SERVICE BULLETIN

M-1181

2006 SERVICE LITERATURE UPDATE

To communicate updates and corrections to 2006 model year service and owner's literature.

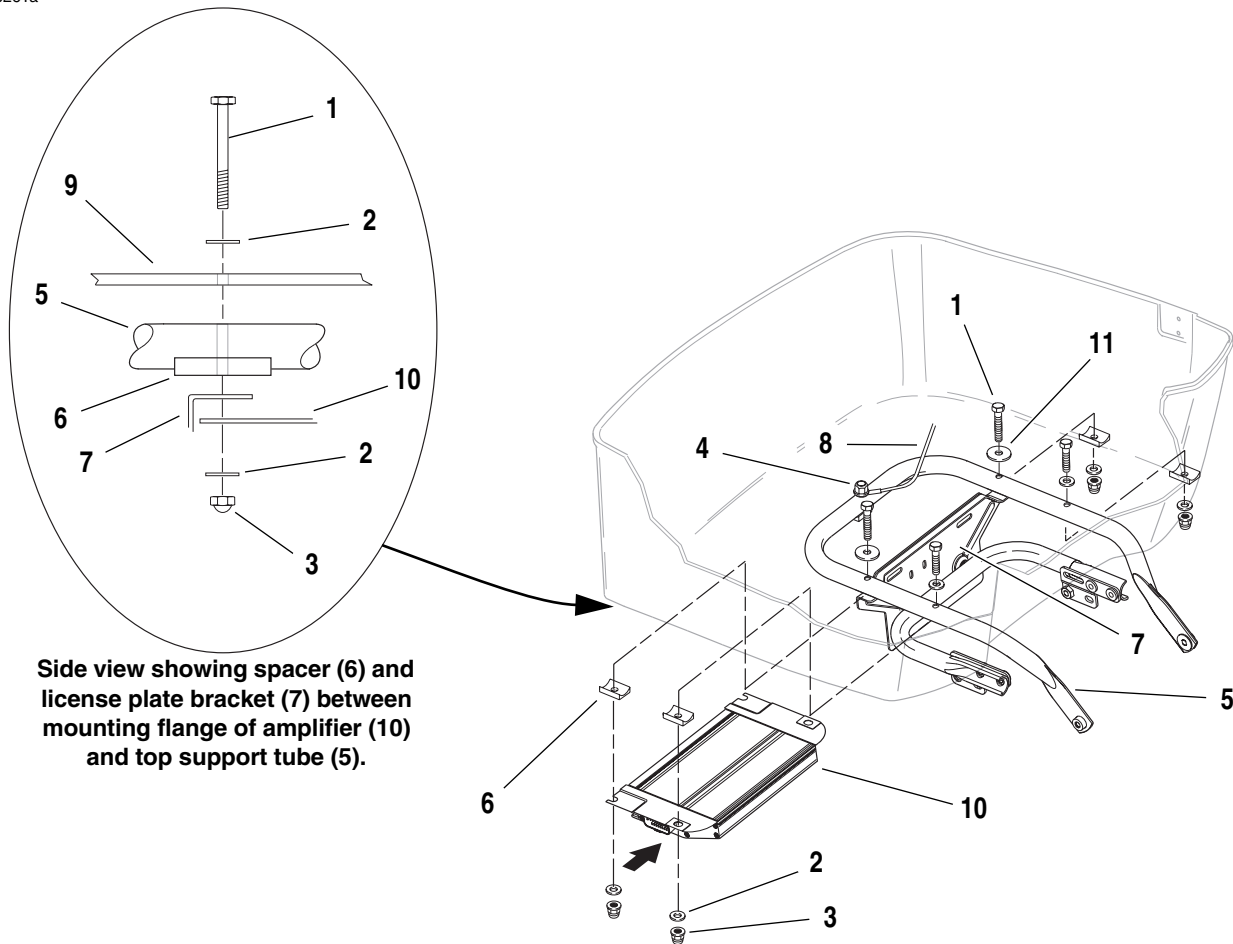
5. See INSTALLING TOUR-PAK® under 7.2 FLHTCUSE MODEL.
 - a. Change step 10 to read as follows: "From inside Tour-Pak, install right rear bolt (1) and large O.D. flat washer (14) through bottom of Tour-Pak (12), hole in top support tube (6), spacer (7), hole in license plate bracket (8) and amplifier (13) flange."

- b. Change step 12 to read as follows: "Install rear bolt (2) from bottom, through spacer, hole in top support tube, bottom of Tour-Pak, flat washer and antenna ground lead (9) ring terminal. Secure with lock nut (5), finger-tight."

6. Update Figure 7-12 with the figure on page 5 of this document.
